CALIFORNIA COASTAL COMMISSION

November 13, 2012

SUBJECT: Addendum to Staff Report for CDP Application E-12-005 and Consistency
Certification CC-027-12, Pacific Gas & Electric Company [See additional correspondence received.](#)

EXHIBIT 6
Morro Bay
Stock of
Harbor
Porpoise
Core Habitat

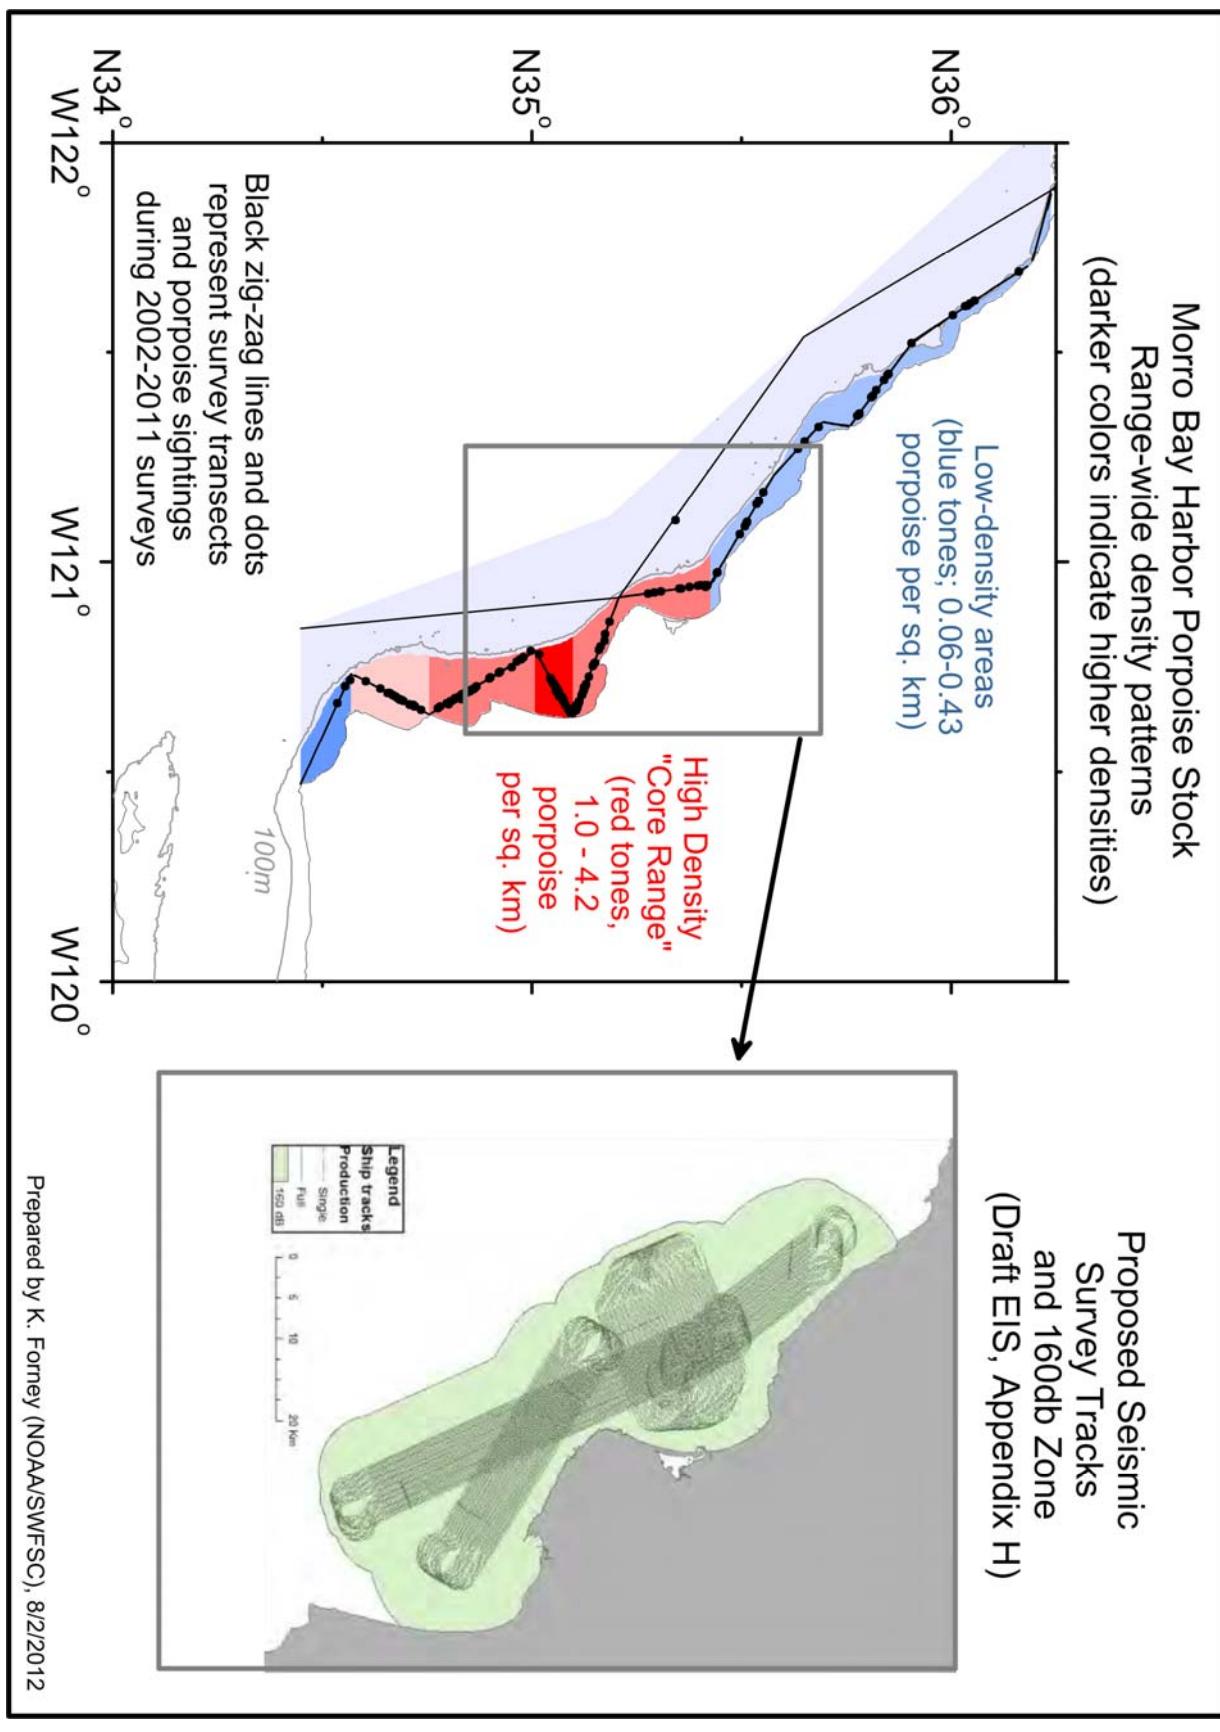
“To further illustrate the points raised above regarding the proposed conduct of active survey operations within the core habitat of the Morro Bay stock of harbor porpoise, Exhibit 6 includes a figure demonstrating the location of this core habitat area in relation to the proposed survey areas and a discussion of the genetic and geographic isolation of this stock from the 2011 U.S. Pacific Marine Mammal Stock Assessments developed by NMFS. This figure supports the assessment of Wood et al. (2012) and NMFS that the proposed project will have significant adverse effects on the Morro Bay stock of harbor porpoise. Marine mammal aerial surveys carried out in the project area on October 2, 2012, the results of which are also included in Exhibit 6, further support these conclusions and demonstrate that harbor porpoise are likely to be present within close proximity of the proposed active survey activities. The survey would effectively close about half of the harbor porpoise core habitat area, and porpoises within that area seeking refuge from the survey would likely either move into the remaining core habitat, thereby increasing competition, or move to more marginal habitat areas.”

EXHIBIT 7a
Expected
Sound
Propagation
Distances

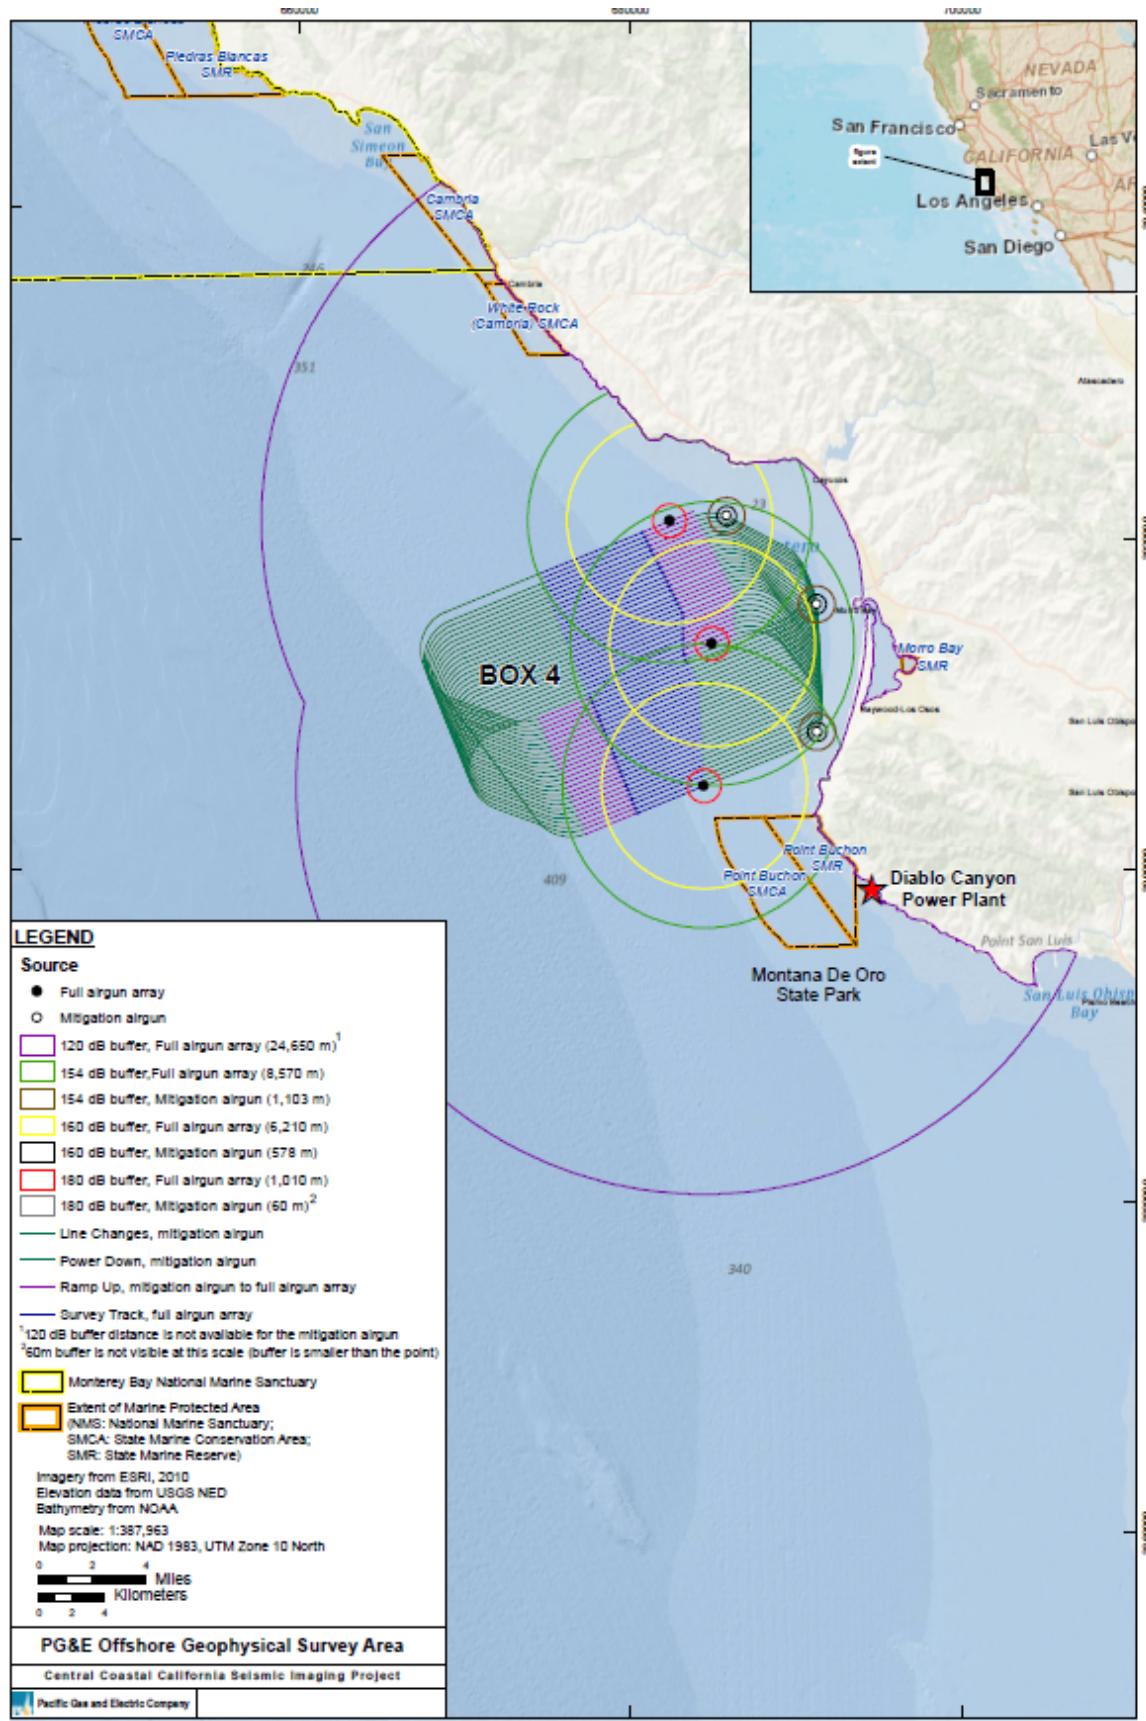
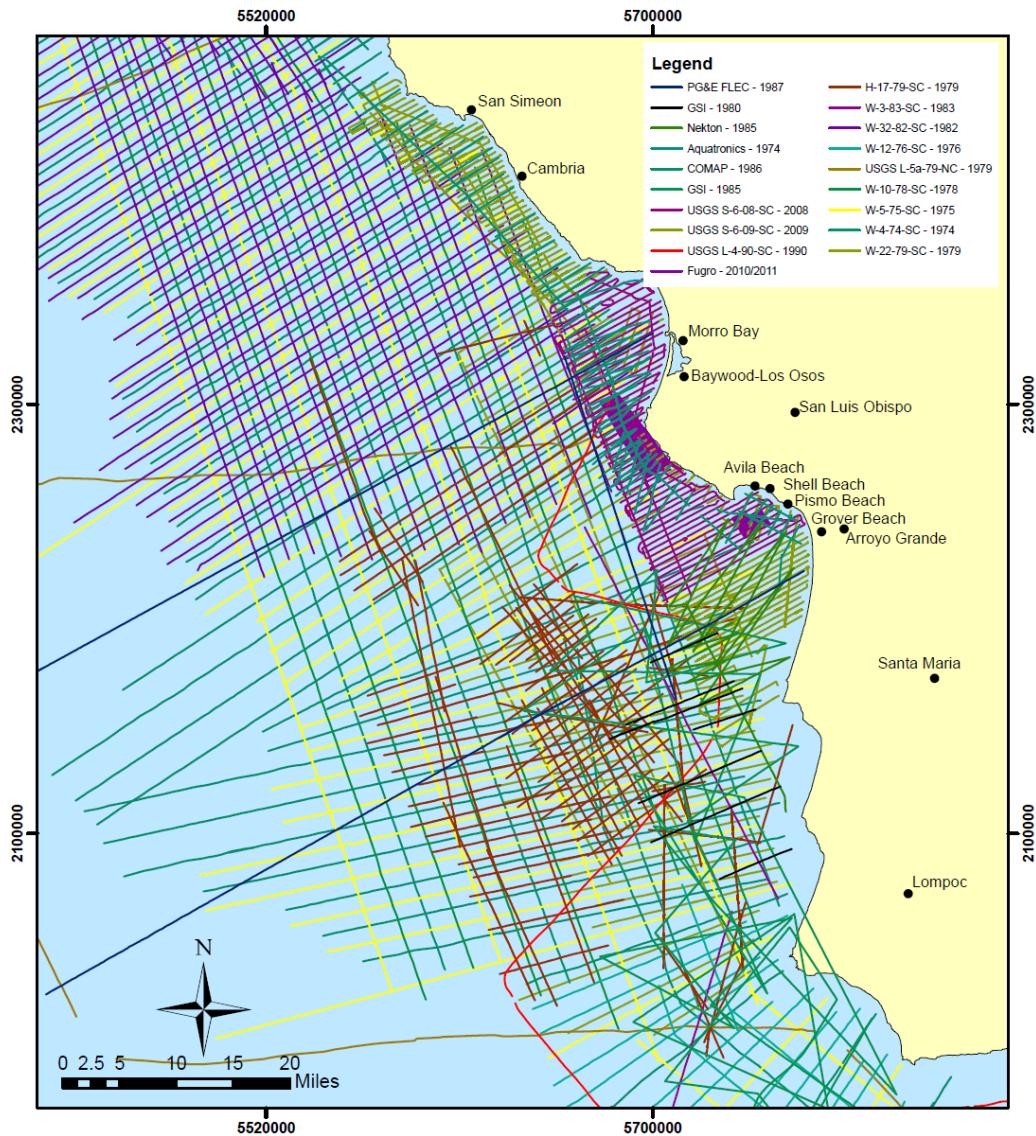
As noted above, PG&E submitted the figure included as [Exhibit 7](#) to demonstrate the anticipated sound propagation distances and received sound levels in beach areas throughout the project area. However, this figure does not accurately depict the anticipated sound levels that would be received in beach and coastal areas within the project area because the vessel locations from which the “full air gun array” sound propagation distances are calculated are further offshore than the survey vessel would be when it begins firing of the full air gun array. As discussed in a letter provided to the Independent Peer Review Panel on October 19, 2012, the full air gun array would begin firing as soon as the vessel completes each turn:

This would substantially increase the received sound levels in nearshore waters along the coast from Montana de Oro State Beach to Cambria beyond those depicted in the figure provided in [Exhibit 7](#). Received sound levels would be expected to exceed 160 dB throughout this area during the proposed survey activities, with the highest levels received each time the survey vessel approaches or completes one of its shoreside turns. Additionally, the sound propagation distances depicted in the figure above are based on the modeled behavior of underwater sound waves in the project area. Until five day sound source verification process is completed at the initiation of active survey operations, the actual sound levels and distances will not be known with complete certainty. As such, the received sound levels in nearshore areas may further exceed or fall short of modeled expectations.
